SERVICE LETTER NUMBER 146			
TITLE: 13000 BULKHEAD #6 CRACK REPAIR			
BY: C. SCHLEMMER	AIRCRAFT MAKE/MODEL(S):	FLOAT MODEL(S):	NOTE(S):
APP: J. SORTOR	DEHAVILLAND TWIN OTTER	13000	COMPLIANCE OPTIONAL S/L P/N 1006027 ECO 24031
DATE: 04/03/15			
REV: B

This service letter applies to all Wipline model 13000 Amphibian and Seaplane Floats S/N 13188(A or S) and below. Subsequent S/Ns incorporate changes in production to preclude cracking. Option 2 can be applied to all S/Ns that experience warping or cracking of the bulkhead main panel after installation of option 1 below has been accomplished or S/N 13189 and on.

Crack appears on 13A01150-052 Bulkhead Body originating from the top rivet hole in the 13A01359-164 LH and 13A01359-165 RH Sister Keel Angle Attach just below the 13A01160-003 LH and 13A01160-004 RH Upper Strut Fitting Panel requiring repair. This kit includes necessary parts to repair and restore integrity of bulkhead.

13A01000-190
BULKHEAD #6 ASSY, RH
(AS SHOWN BEFORE REPAIR)

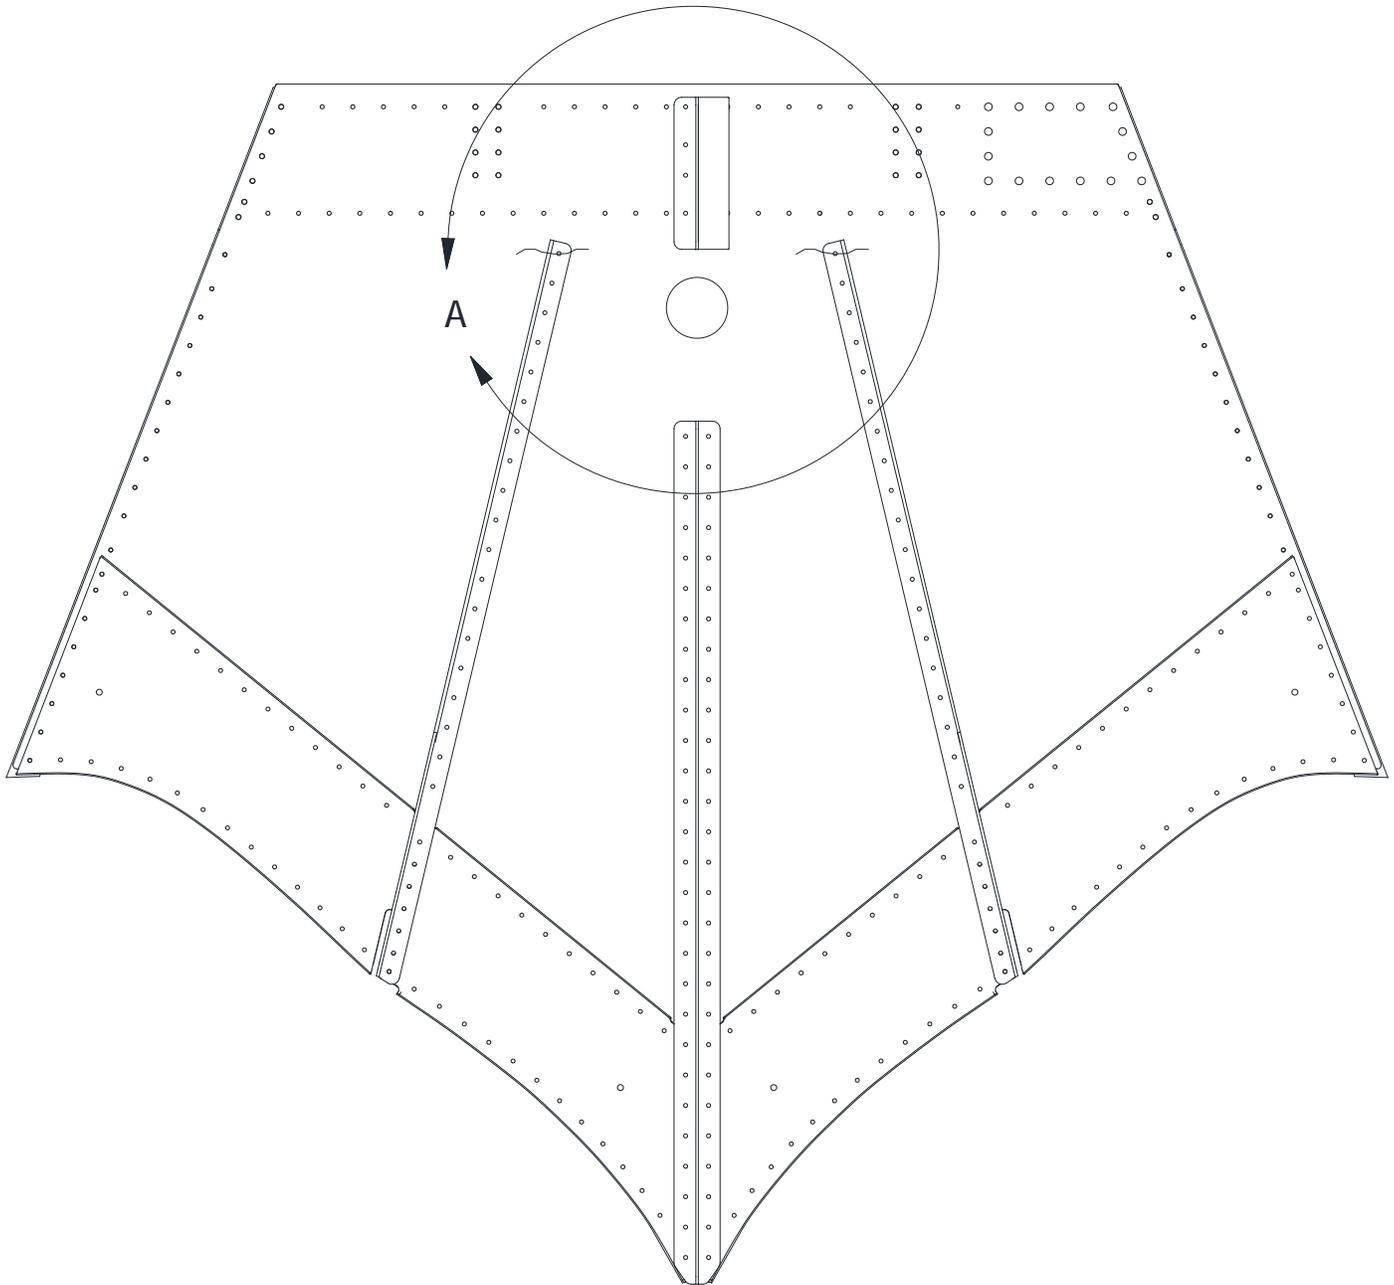
3. Remove second and third top covers from the front to access 13A01000-190 or -243 bulkhead #6 assembly.
4. Drill out top 7 rivets of 13A01359-165 and -164 sister keel angles and cut off angles as shown in drawing.

DETAIL A

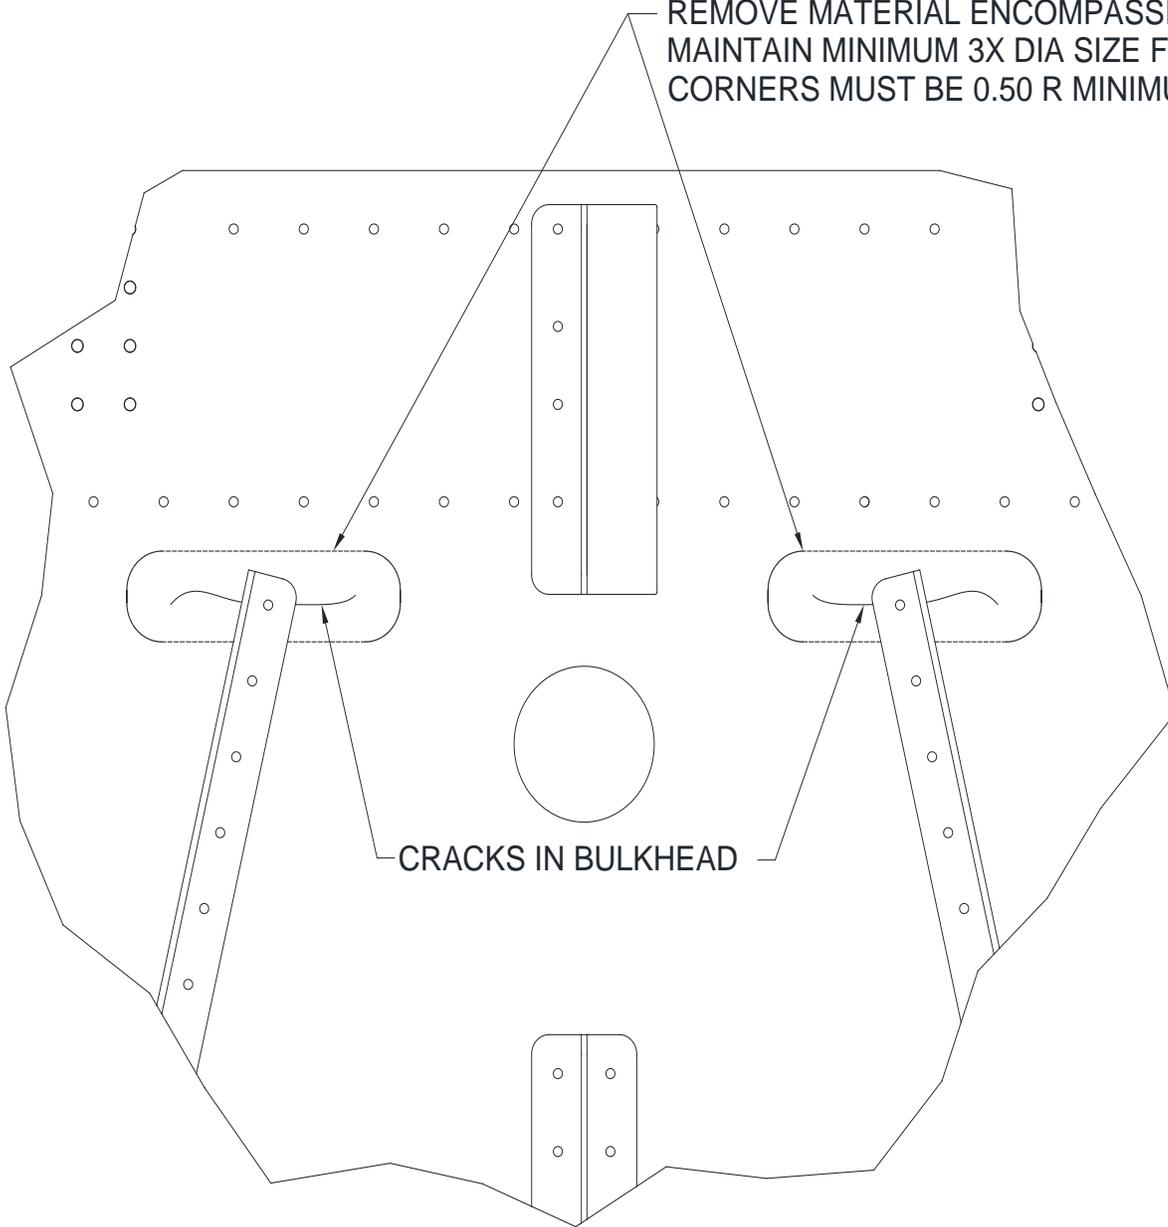
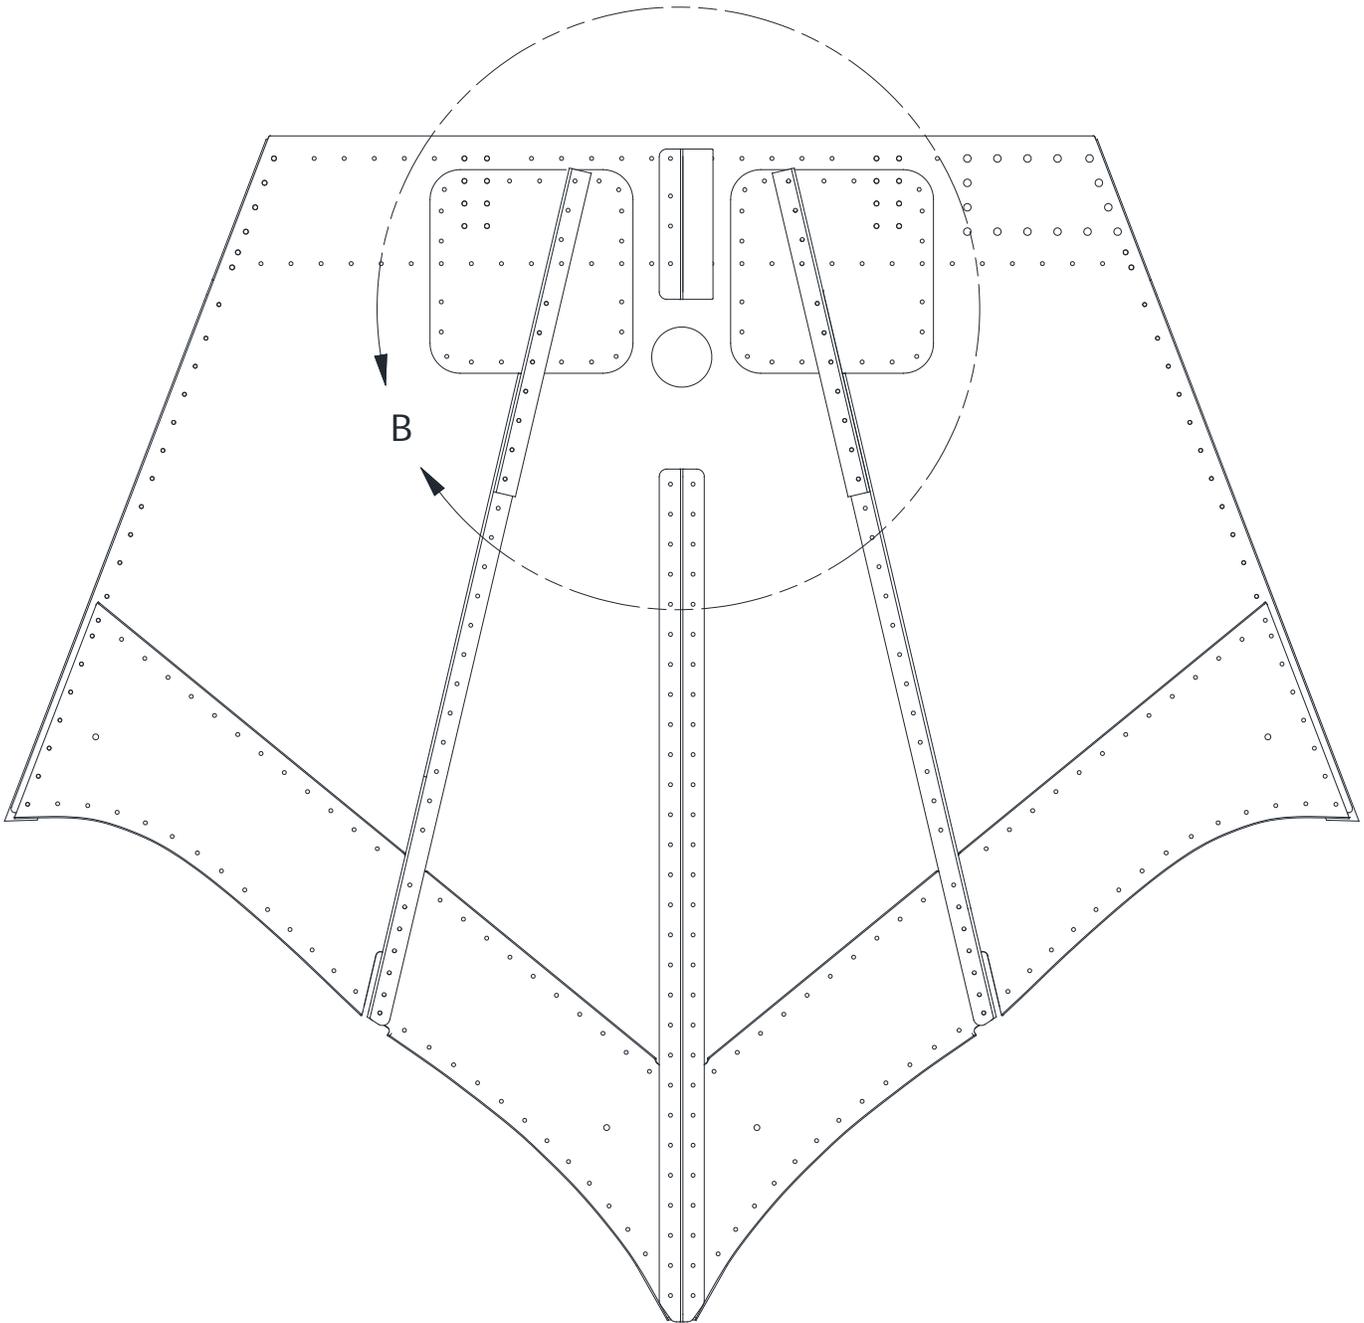
5. Drill out remaining rivets in boxed area as shown in Detail A drawing.
6. Trim bulkhead material to completely remove crack. Radius corners of trimmed area to 0.5" minimum. Maintain minimum distance of 3 times the diameter size from rivet line.

REMOVE MATERIAL ENCOMPASSING CRACKS.
MAINTAIN MINIMUM 3X DIA SIZE FROM RIVET LINE.
CORNERS MUST BE 0.50 R MINIMUM.

7. Place 1006021 patch and 1006020 RH and 1006035 LH angle onto bulkhead panel and line up holes then rivet the parts to the panel using MS20470AD Rivets.

8. Match drill remaining holes from 1006021 patch and 1006020 RH and 1006035 LH angle to the panel.
9. Complete the riveting of the parts using MS20470AD Rivets.

13A01000-190
BULKHEAD #6 ASSY, RH
(AFTER REPAIR)

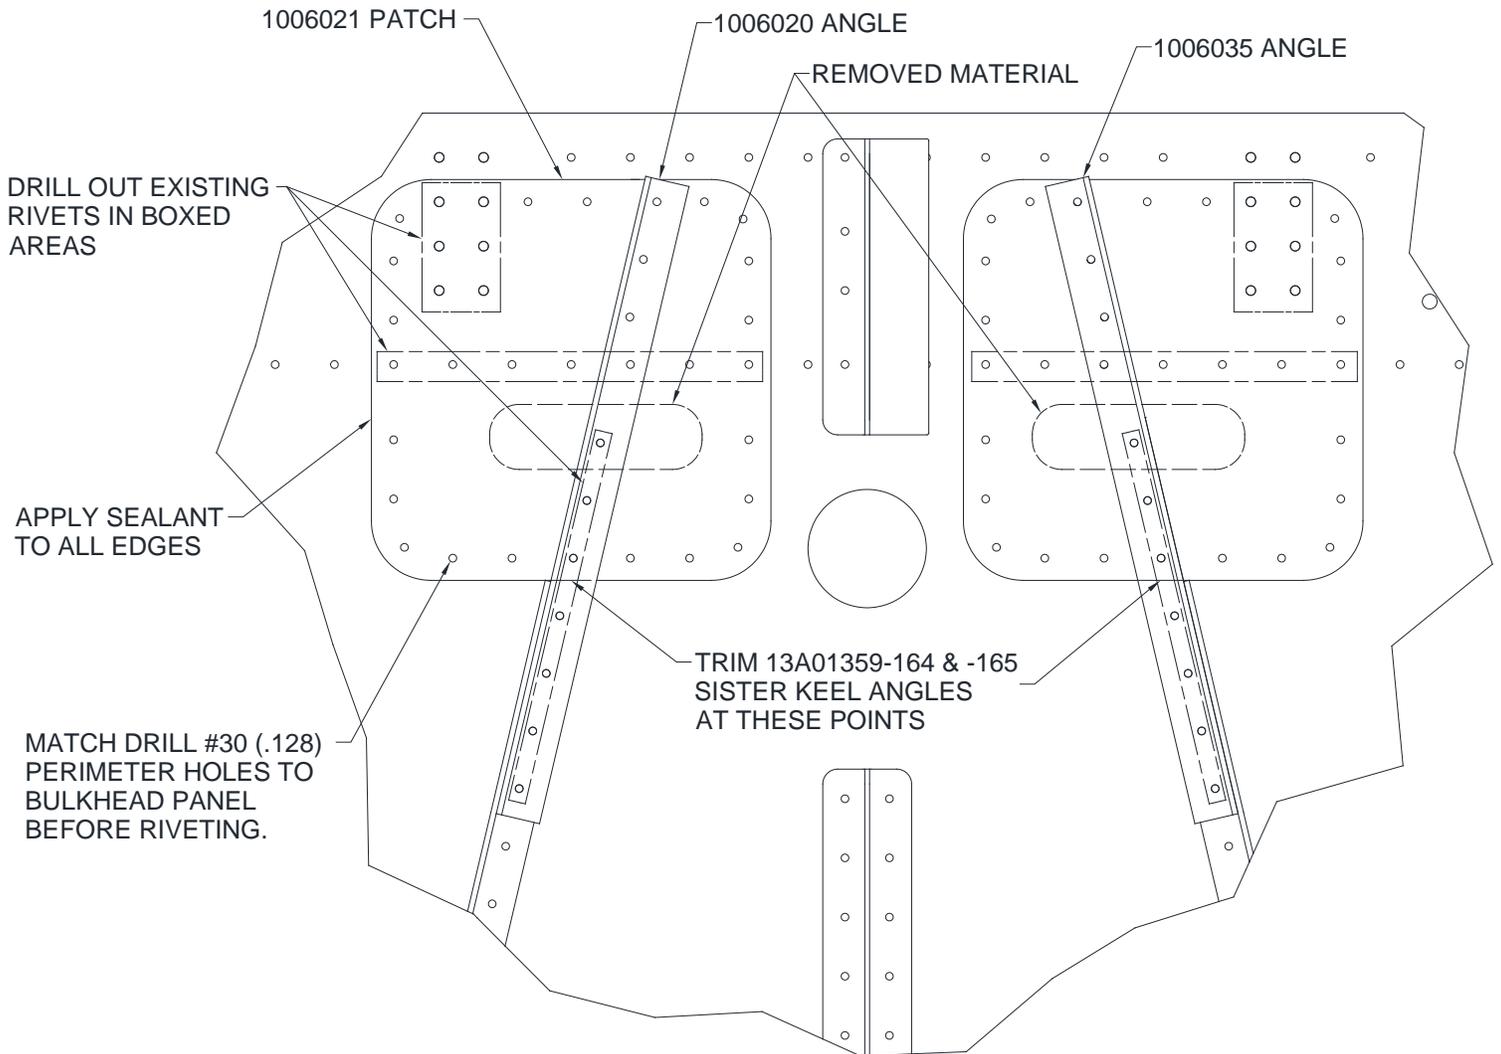
10. Apply sealant around patch edges.
11. Reinstall access covers.

Figure 1 – Bulkhead Splice Repair

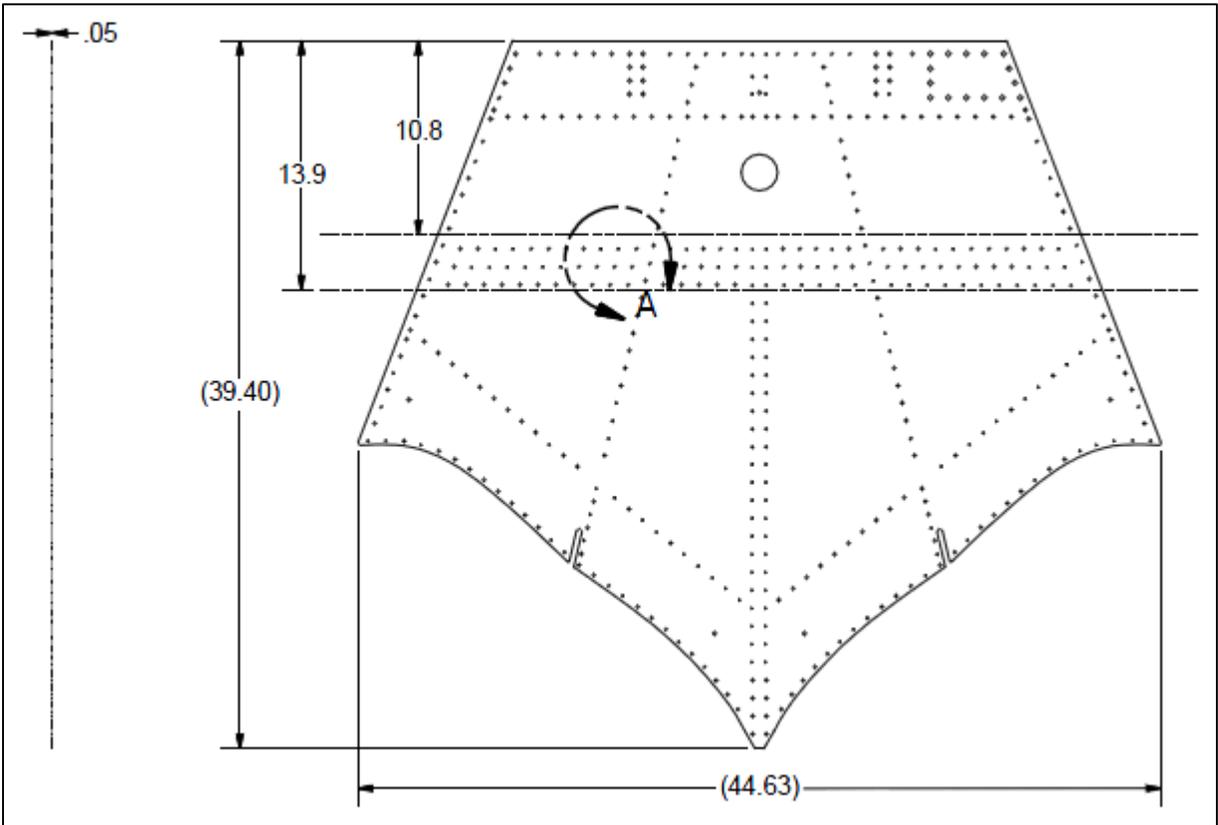
3. Remove required internal stiffeners, side skin attach arms, and top rail attach angle attached to bulkhead #6 as required to complete step 2.
4. Remove the damaged upper portion of the bulkhead body in location indicated by Figure 1.

5. Replace upper section of bulkhead with an upper portion from a new bulkhead body (Wipaire part number 13A01150-052), creating an overlap splice with the original lower section of the bulkhead body as indicated in Figure 1.

6. Reinstall all stiffeners and attach angles using “as designed” rivets, locations and sizes, except in the location of the overlap splice in the bulkhead body. At the splice location, install MS20470AD5 rivets, in original position, length as required. This requires upsizing the holes in the attach angles and stiffeners in the location of the splice; specifically 3 holes in each, except the center “T” section, which will have 6 holes up-sized.

7. Install an additional 96 MS20470AD5 rivets (length as required) in the splice of the bulkhead body as indicated in Figure 1: 11 columns of 3 between the side skin attach arm and the sister keel attach angle on both sides of the bulkhead body; and 5 columns of 3 between the sister keel attach angle and the center “T” section, on both sides of the bulkhead. For the additional 96 rivets, the spacing is defined in Figure 2.

- FL1: Position rivet columns adjacent to stiffeners and attach flanges 0.8 (TYP) from the edge of the stiffener or attach flange. Provide equal horizontal spacing between the remaining required intermediate rivets. Final horizontal spacing dimensions shall be between 0.7 – 1.0” for the intermediate rivets.
- FL2: Maintain original rivet location in bulkhead body and all stiffeners, except upsize holes in spliced area to accommodate MS20470AD5 rivets (diameter 0.159”).
